From: Tim Townsend [REDACTED]
Sent: 14 March 2018 09:59
To: Planning.Responses
Cc: Michael Eastham; Gary Markwell
Subject: LU/426/17/DOC - Porposed acoustic barrier - Fitzalan Relief Road - WSCC Highways response dated 14th March 2018

SUBJECT: LU/426/17/DOC - Approval of details reserved by condition imposed under LU/234/16/RES relating to condition 7 for details of acoustic barrier.

LOCATION: Fitzalan Link Road, East Street, Littlehampton, West Sussex.

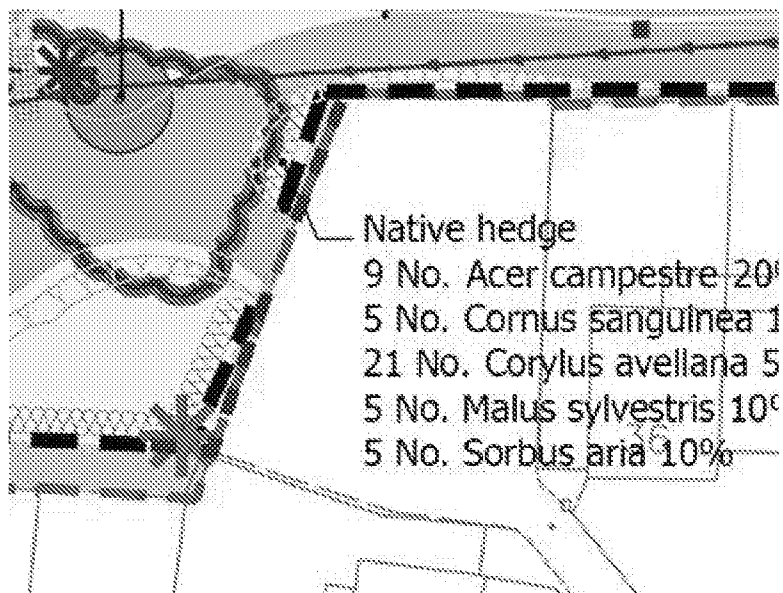
Location of acoustic fence alongside parking court adjacent to 36 Highdown Drive (near the proposed toucan crossing) – WSCC Highways will be asking for the noise barrier to be installed to replace the existing fencing (on blue dashed line) so as to limit access to the maintenance area to the north thus:

It currently looks like this: (Note that some form of barrier to delineate the route and to prevent car access will be required at the S38/278/detailed design stage as will tidying-up of the area as may reasonably be required):
